Arizona Department of Transportation

MEMORANDUM

Subject: C-Standards Update

Construction Standard Drawings Revisions – April 2006

APPROVED FOR DESIGN <i>May Vipawina</i>	STATE OF ARIZONA DEPARTMENT OF TRANSPORTATION ROADWAY STANDARD DRAWINGS	REV. 4/06
APPROVED FOR DISTRIBUTION <i>John Smith</i>	SLOPES RURAL UNDIVIDED AND FRINGE-URBAN HIGHWAYS	DRAWING NO. C-02.20

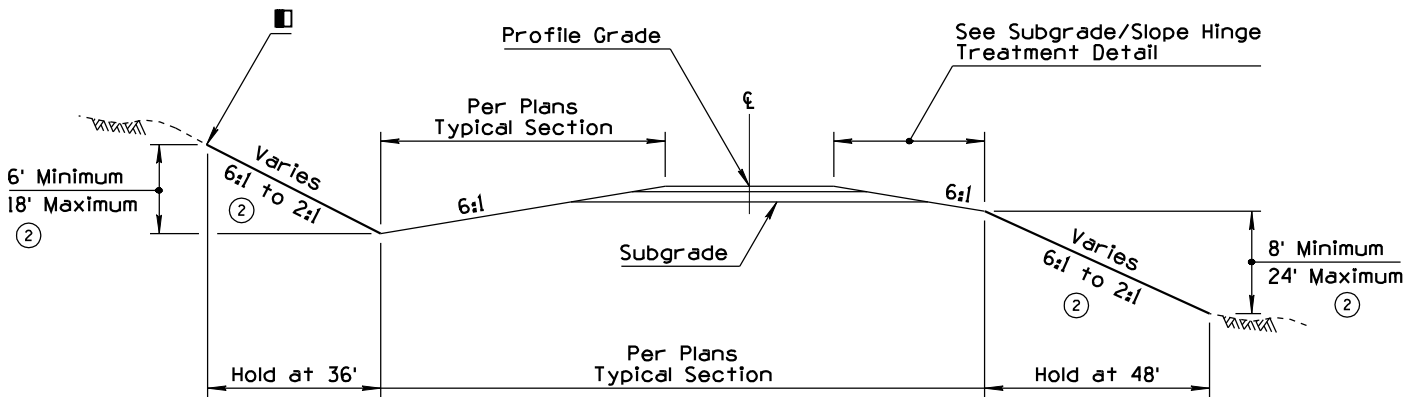
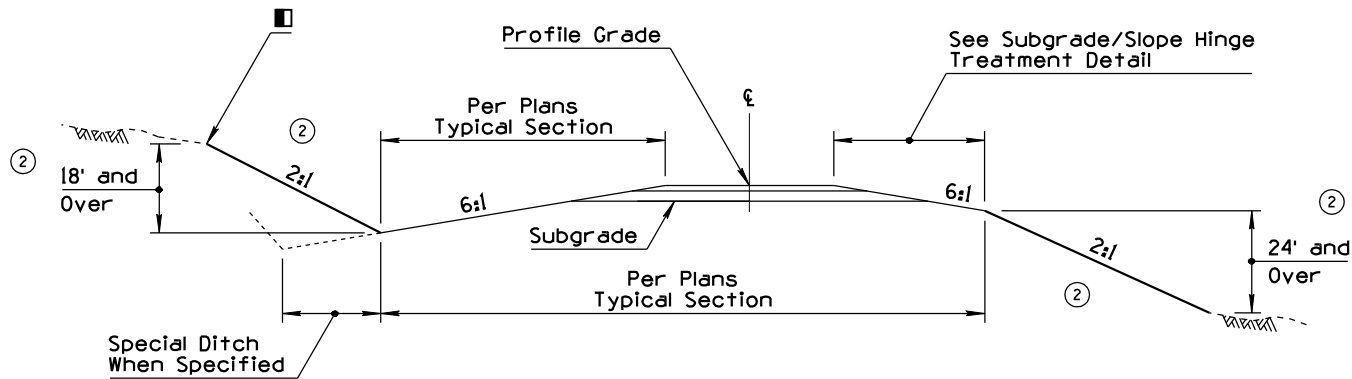
Please refer to the updated Construction Standard Drawings (Rev.date 4/06) that were issued today under separate e-mail notification. The maximum fill slope rates for Std. C-02.20 Rural Undivided and Fringe-Urban Highways and Std. C-02.30 Miscellaneous Roadways have been revised from 1 1/2:1 to 2:1. Also, the maximum cut slope rates for these two standards have been revised from 1:1 to 2:1. No slope changes have been made to Std. C-02.10 Rural Divided Highways. These revisions have been coordinated with the Materials Group Geotechnical Design.

The revisions to the slopes reflect what has been the norm for most projects. The 2:1 fill slopes provide a more stable embankment and provide an improved slope rate to establish vegetation and erosion control. The flatter 2:1 cut slope rates will also provide the same advantages. When in rock cuts, Geotechnical Design will continue to provide the maximum slope that can be used by the designer. Also, when cuts are in the higher ranges and there may be a significant project cost involved, Geotechnical Design will provide the designer the maximum slope that can be used to reduce the excavation required. The design process for establishing slope design for a project has not changed. The standard slopes simply provide the initial design slopes and the designer is to adjust the slopes for the project needs considering safety, material type, project costs, slope stabilization and other needs.

NO	DESCRIPTION OF REVISIONS	MADE BY	DATE
1	REVISED TITLE	RLF	4/06
2	MODIFIED SLOPE CRITERIA	RLF	4/06
3			
4

APPROVED FOR DESIGN <i>May Vipawina</i>	STATE OF ARIZONA DEPARTMENT OF TRANSPORTATION ROADWAY STANDARD DRAWINGS	REV. 4/06
APPROVED FOR DISTRIBUTION <i>John [Signature]</i>	SLOPES MISCELLANEOUS ROADWAYS ①	DRAWING NO. C-02.30

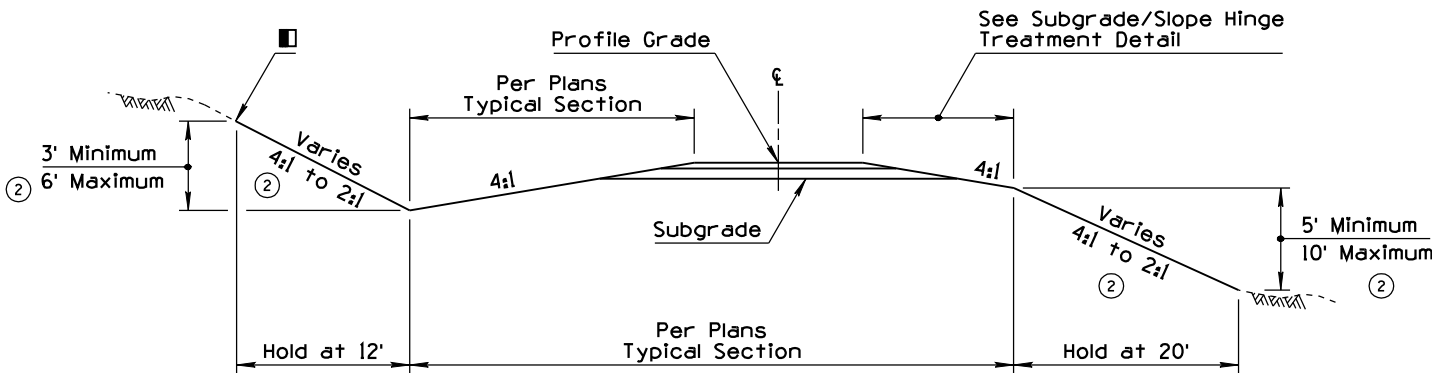
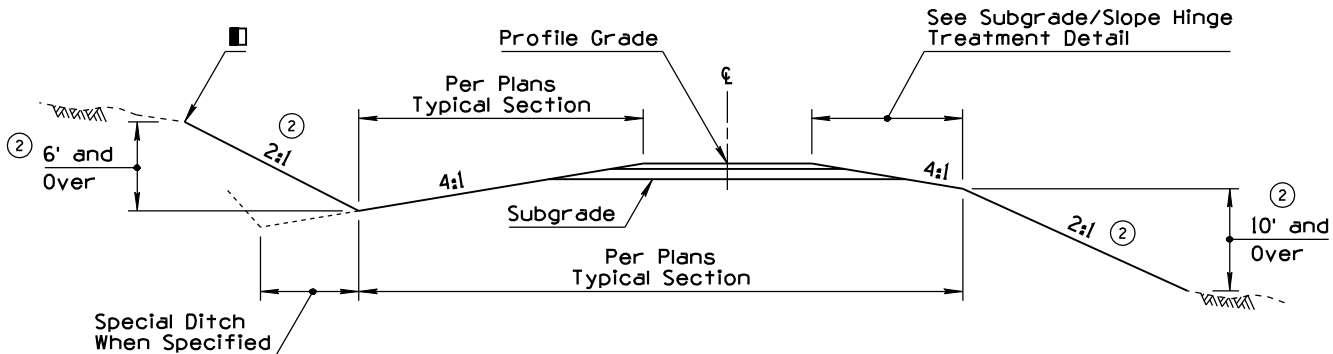
NO	DESCRIPTION OF REVISIONS	MADE BY	DATE
1	MODIFIED TITLE	RLF	4/06
2	MODIFIED SLOPE CRITERIA	RLF	4/06
3	ADDED USAGE NOTE	RLF	4/06
4

- ③ USE OF THIS STANDARD IS LIMITED. SEE ROADWAY DESIGN GUIDELINES, SECTION 306.2.
- The 6' minimum is required when guardrail is utilized on the project. Treatment shall be uniform throughout the project length. The 6' requirement may be waived under special conditions where guardrail is not utilized.

APPROVED FOR DESIGN <i>May Vipawina</i>	STATE OF ARIZONA DEPARTMENT OF TRANSPORTATION ROADWAY STANDARD DRAWINGS	REV. 4/06
APPROVED FOR DISTRIBUTION <i>John Smith</i>	SIDEWALK RAMP TYPE D	DRAWING NO. ① C-05.30 Sheet 4 of 7

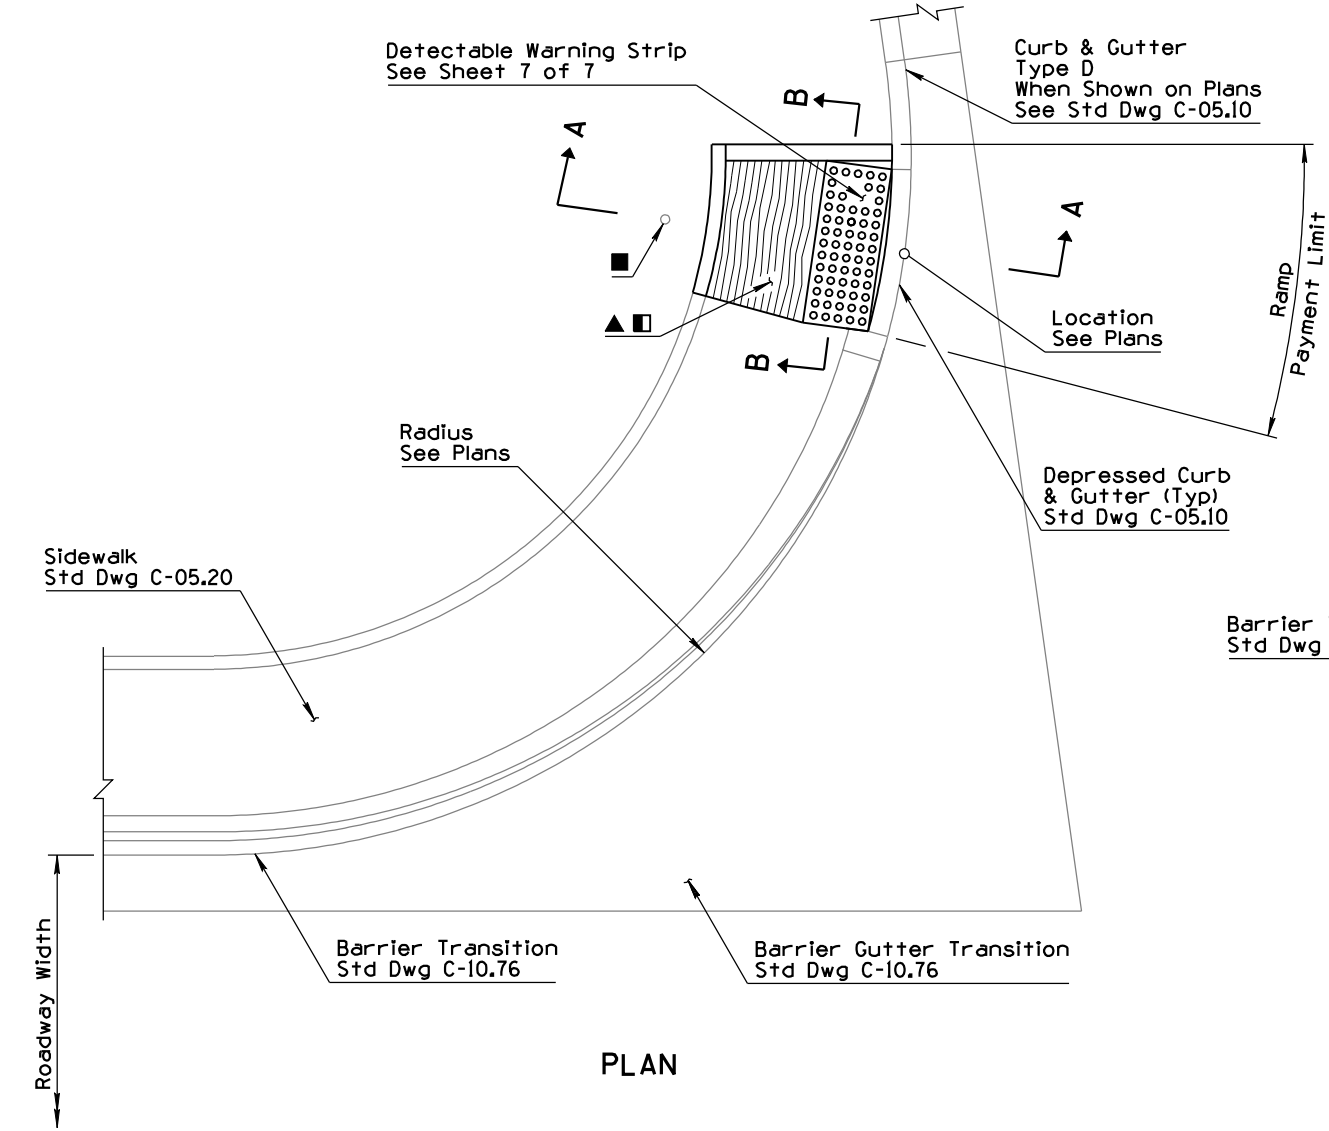
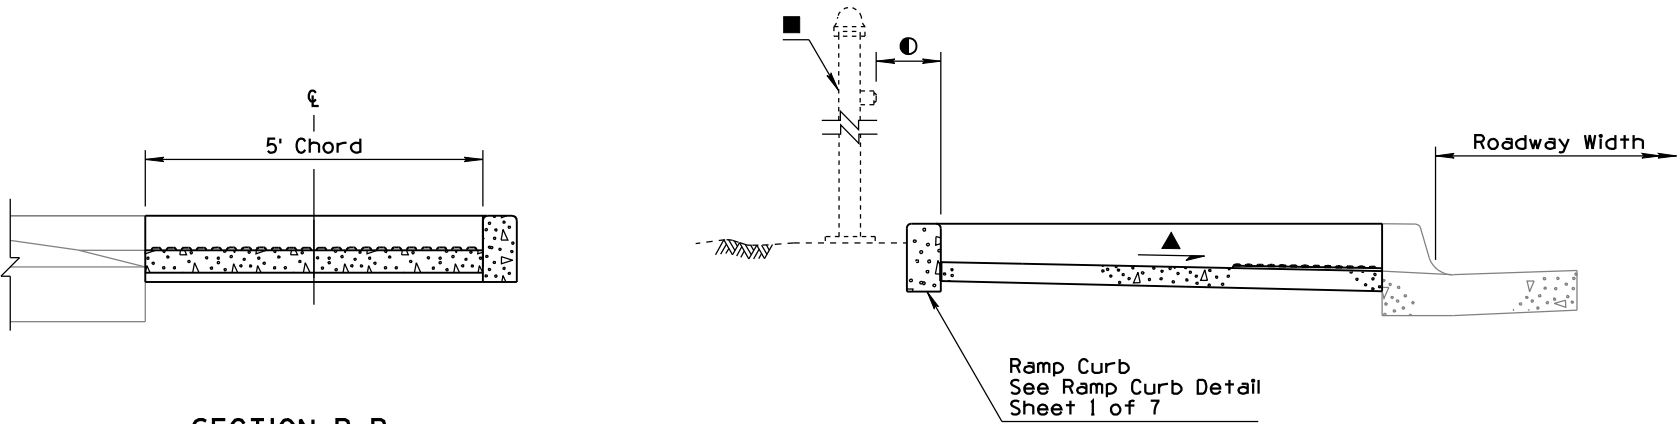
- C-02.20 & C-02.30: Revised cut and fill slope dimensions;
- C-05.30, Shts 3 & 4 of 7: Modified PLAN and PERSPECTIVE views to clarify ramp location;
- C-05.30, Sht 7 of 7: Added a PLAN and SECTION views for a brick detectable warning strip;
- C-10.76: Modified SECTION views to depict "F" shape; and
- C-11.10: Re-issued the drawings in four sheets. Sheet 4 shows the clamp designed to enhance the bicycle ridability of the cattle guard.

C-05.30, Sheet 4 of 7	Modified ramp location in PLAN and PERSPECTIVE views.
C-05.30, Sheet 5 of 7	Modified General Note 3.
C-05.30, Sheet 7 of 7	Added PLAN and SECTION views of brick option Detectable Warning Strip (DWS). Modified PLAN view of non-brick DWS. Added General Note 1. Re-labeled section and detail views.
C-05.50	Revised General Note 6. Rearranged drawings on sheet. Modified SECTION A--A. Revised Std Dwg reference in SECTION C--C. Re-labeled "PLAN VIEW OF SECTION C--C".
C-07.02	Revised General Notes 3 & 4 to correct Std Dwg reference from C-07.05 to C-07.04. Revised drawing titles.
C-10.51	Changed "PLAN VIEW" to "PLAN". Removed slope designation from sidewalk in SECTION views. Changed length of vertical taper from 12½" to 1'-0". Revised text orientation. Added "WITHOUT GUARDRAIL" to title of ELEVATION view of departure vertical taper.
C-10.52	Removed "D" reference and substituted "may" for "can" in General Note 5.

APPROVED FOR DESIGN <i>May Vipawina</i>	STATE OF ARIZONA DEPARTMENT OF TRANSPORTATION ROADWAY STANDARD DRAWINGS	REV. 4/06
APPROVED FOR DISTRIBUTION <i>John Smith</i>	SIDEWALK RAMP DETECTABLE WARNING STRIP	DRAWING NO. C-05.30 Sheet 7 of 7

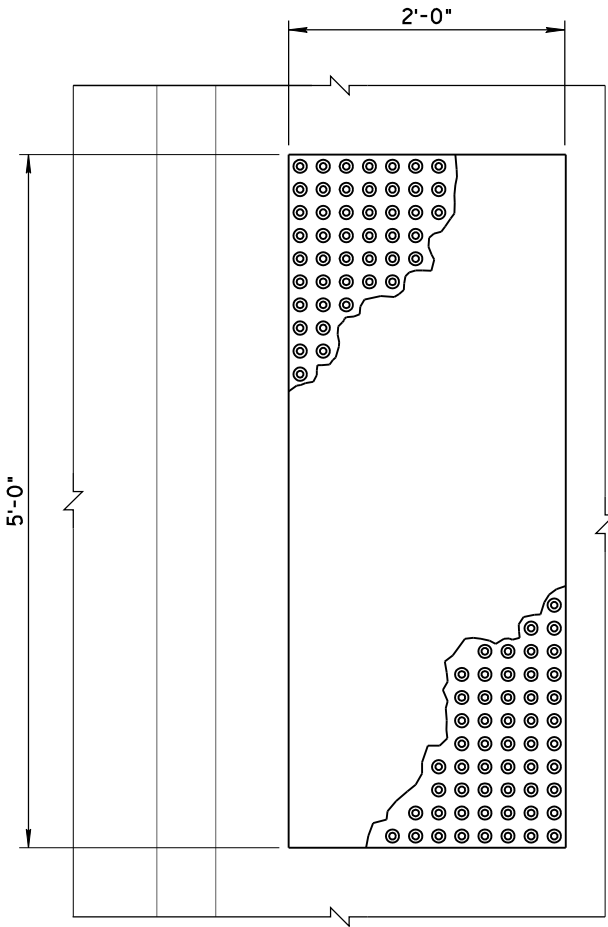
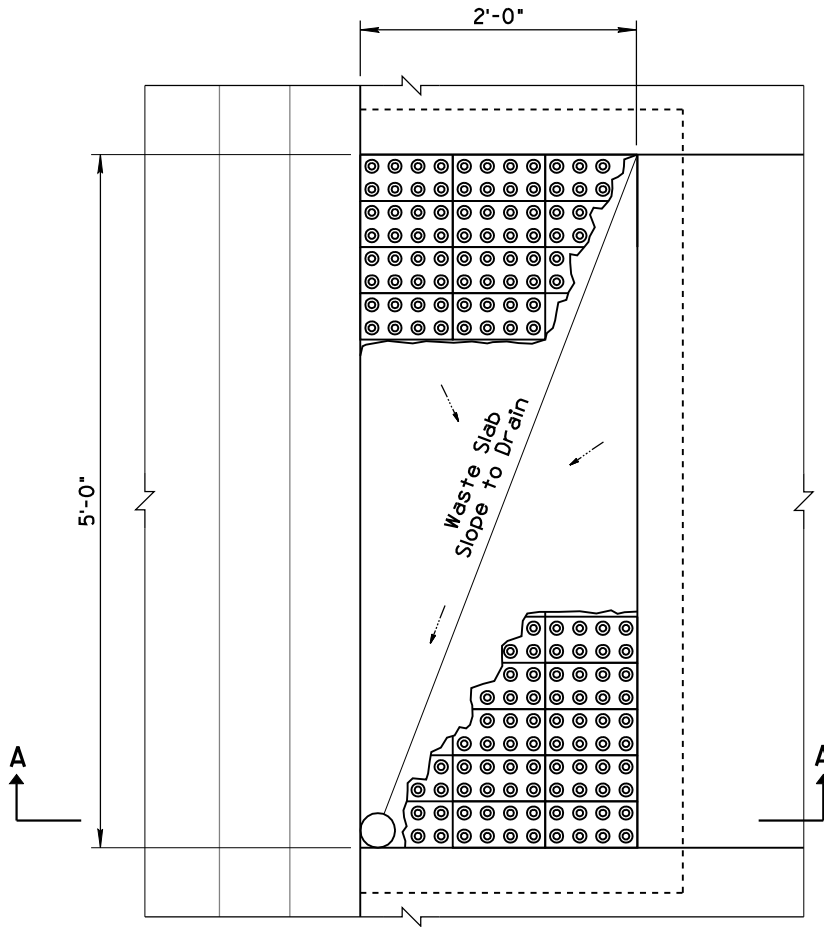
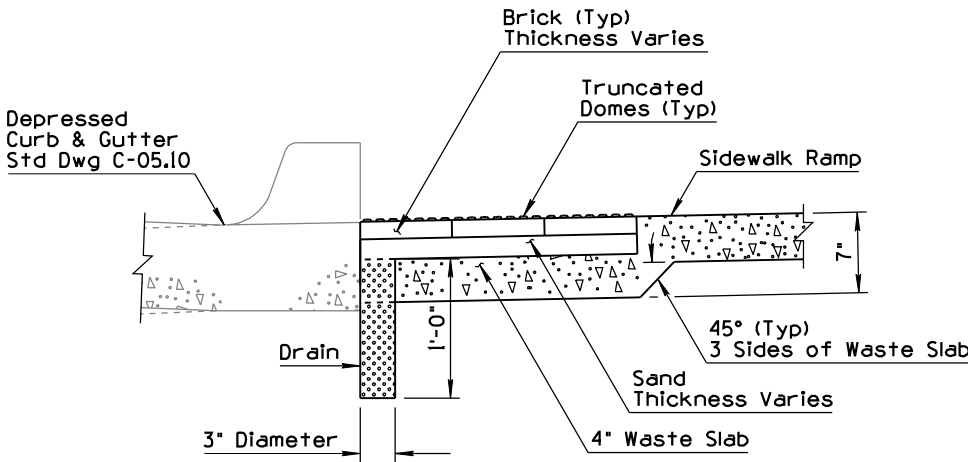
NO	DESCRIPTION OF REVISIONS	MADE BY	DATE
1	ADDED PLAN & SECTION FOR BRICK OPTION	RLF	4/06
2	REVISED TITLE	RLF	4/06
3			
4

APPROVED FOR DESIGN <i>May Vipawina</i>	STATE OF ARIZONA DEPARTMENT OF TRANSPORTATION ROADWAY STANDARD DRAWINGS	REV. 4/06
APPROVED FOR DISTRIBUTION <i>John [Signature]</i>	CONCRETE HALF BARRIER 32' TYPE 'F' WITH SIDEWALK	DRAWING NO. C-10.51

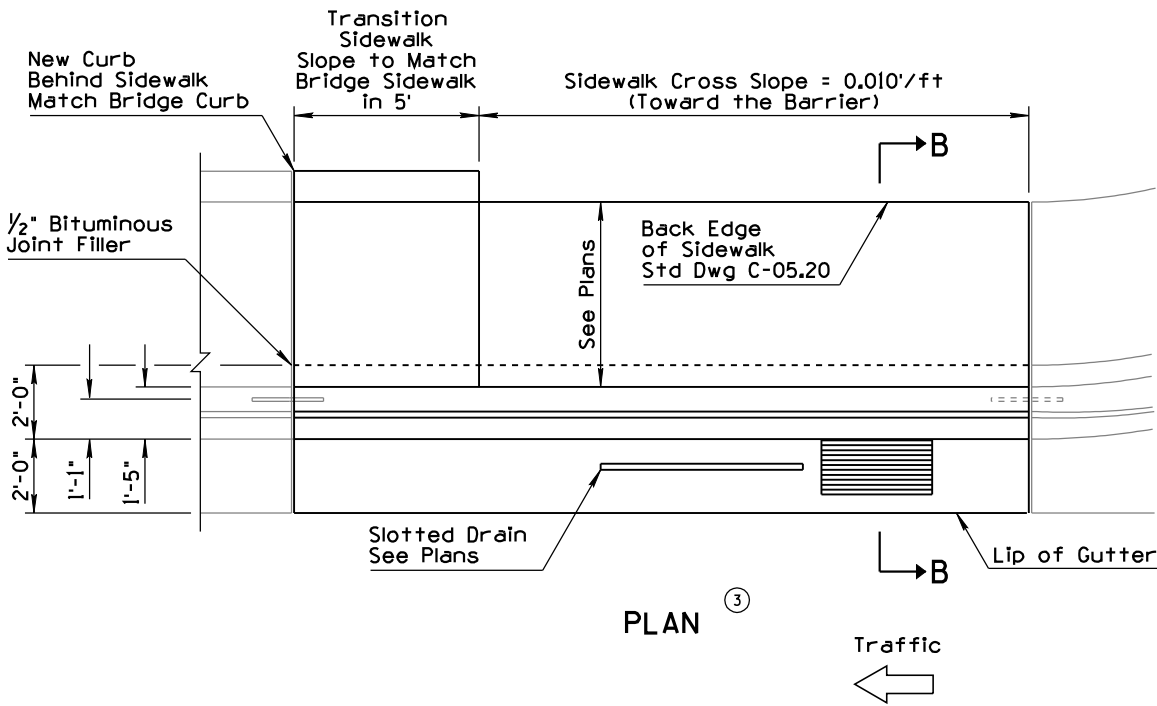
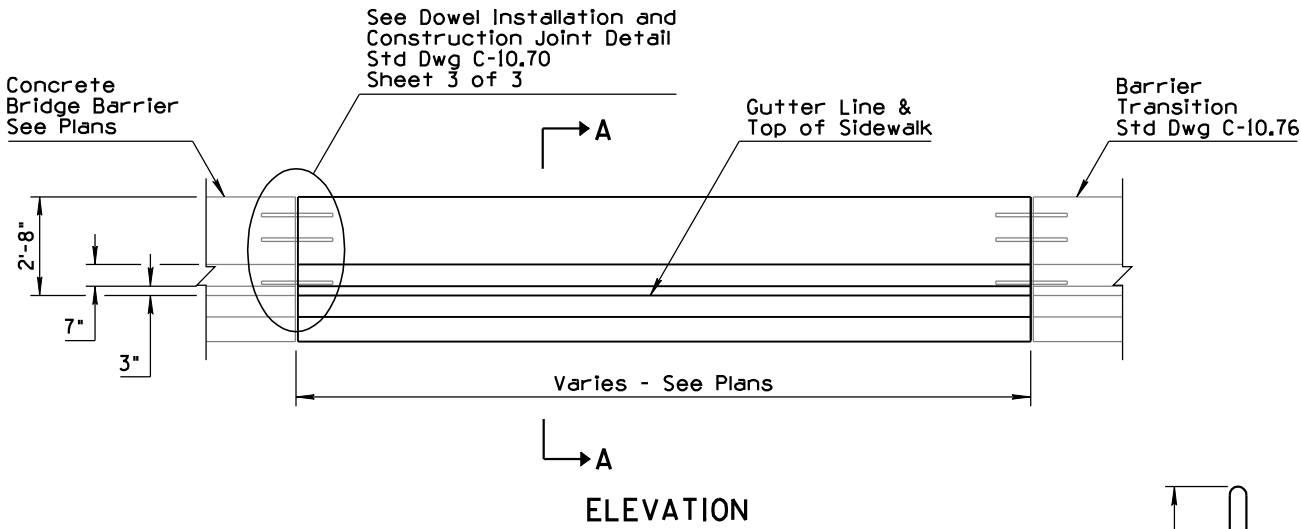
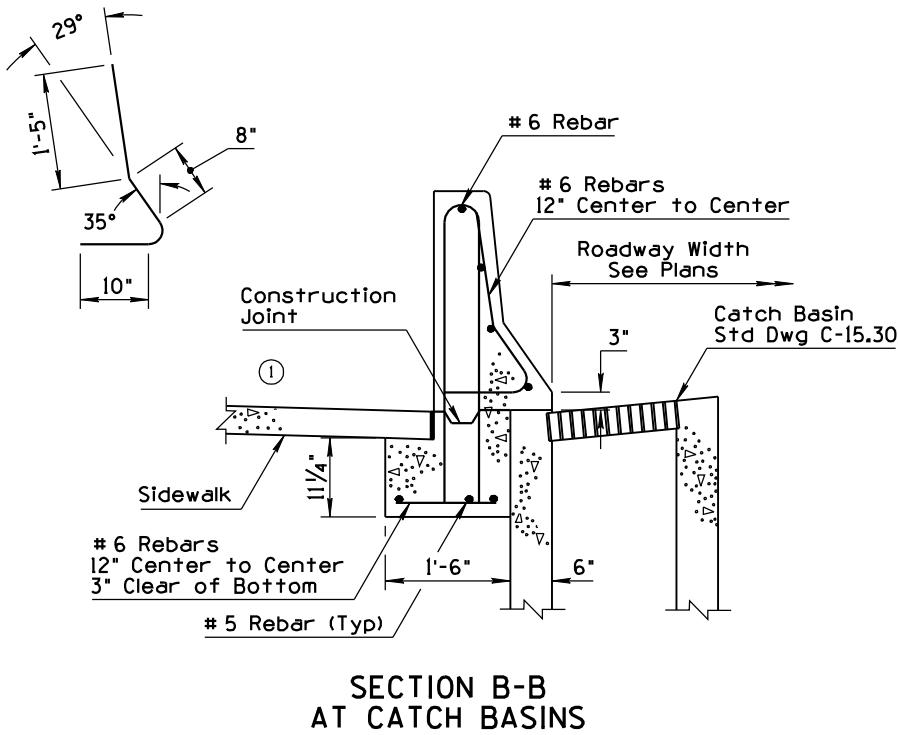
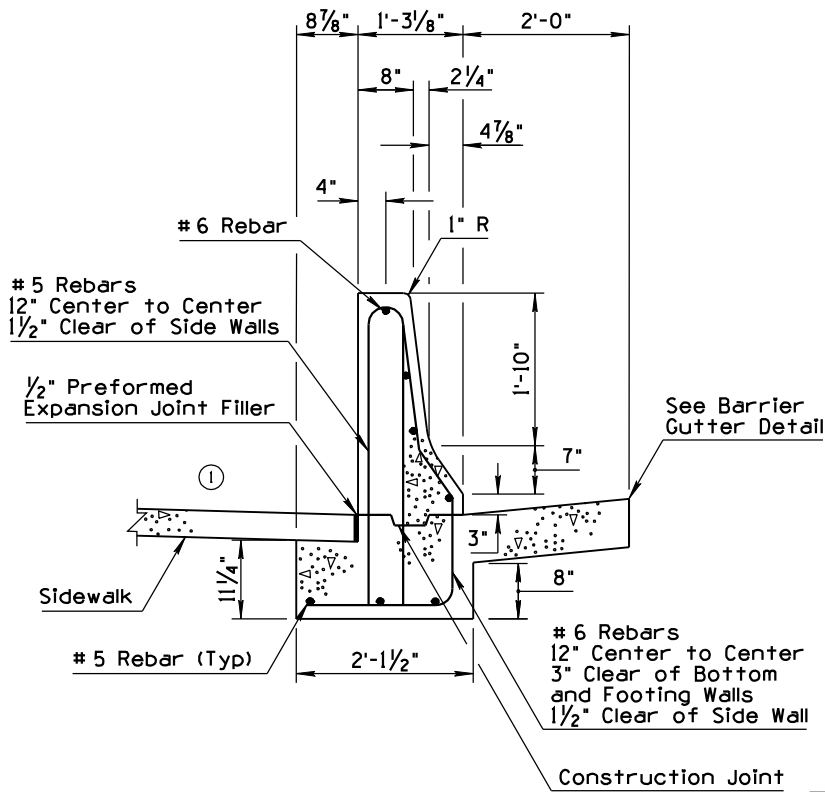
NO	DESCRIPTION OF REVISIONS	MADE BY	DATE
1	MODIFIED SECTION VIEWS; REMOVED SLOPE DESIGNATION	RLF	4/06
2	WAS 12½" - IS NOW 1' & ADDED WITHOUT GUARDRAIL TO TITLE	RLF	4/06
3	MODIFIED TITLE	RLF	4/06
4
